Access Compliance Report

Public Rights-of-Way

(Curb Ramps)

Intersection ID: 10032199	Main Street: MORROW_ST	Cross Street: ELIZABETH_AV	Location:	N
ADA ID: C21E8B3DC749	Ramp Type: BlendTrans2	Initial Pass/Fail: Fail	Overall Compliance: No	Severity Score: 25

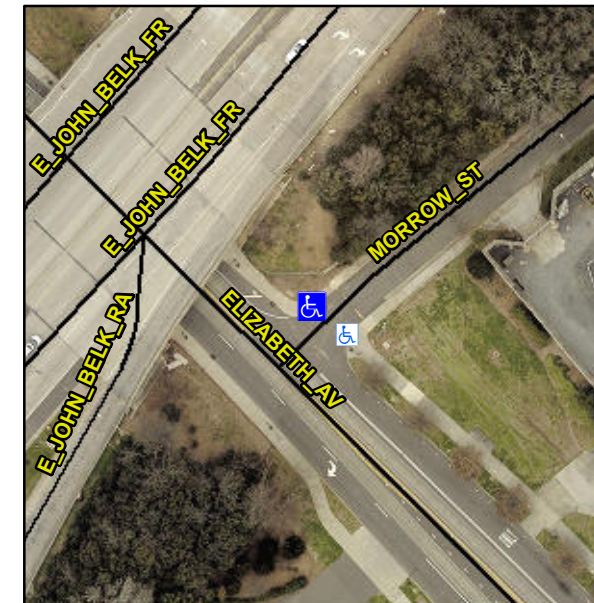
R304.5.3

Compliance	Description	Data	Compliance	Description	Data
N/A	Ramp Length (in)	70.0	Yes	BlendTrans Slope (%)	3.2
Yes	Ramp Width (in)	48.0	No	BlendTrans XSlope (%)	9.2
N/A	Flare Type LT	N/A	N/A	Flare Type RT	N/A
N/A	Flare Slope LT (%)	N/A	N/A	Flare Slope RT (%)	N/A
N/A	Flare Traversable LT?	N/A	N/A	Flare Traversable RT?	N/A
N/A	Landing Length (in)	N/A	N/A	DWS Provided?	N/A
N/A	Landing Width (in)	N/A	N/A	DWS Contrast?	N/A
N/A	Landing Slope (%)	N/A	N/A	DWS Length (in)	N/A
N/A	Landing X Slope (%)	N/A	N/A	DWS Full Width?	N/A
N/A	Landing Curb? (Y/N)	N/A	N/A	DWS Offset (in)	N/A
N/A	Shared Landing?	N/A			
N/A	Gutter Ponding?	N/A	N/A	Gutter Slope (%)	N/A
N/A	Gutter Lip Ht (in)	N/A	N/A	Gutter X Slope (%)	N/A
N/A	Painted X Walk1?	No	N/A	Painted X Walk2?	N/A
	X Walk 1 Direction	To SE		X Walk 2 Direction	N/A
	X Walk 1 Width (in)	N/A		X Walk 2 Width (in)	N/A
	X Walk 1 Slope (%)	2.8		X Walk 2 Slope (%)	N/A
	X Walk 1 X Slope (%)	9.7		X Walk 2 X Slope (%)	N/A

N/A	Ramp inside XWalk1?	N/A	N/A	Ramp inside XWalk2?	N/A
	Road Slope (%)	9.7		Clear Space?	N/A
	Road X Slope (%)	2.8	N/A	Clear Space to XWalk (in)	N/A
N/A	Any Obstructions?	N/A	N/A	Storm Grate/Utility Hazard?	N/A
	Obstruction Type			Storm Grate/Utility Type	
		N/A			N/A
			Yes	Surface Condition? (G/P)	Good
			N/A	Curb Slope (%)	0.2

Remove & Replace Curb Ramp With Two New Directional Ramps or Equivalent.
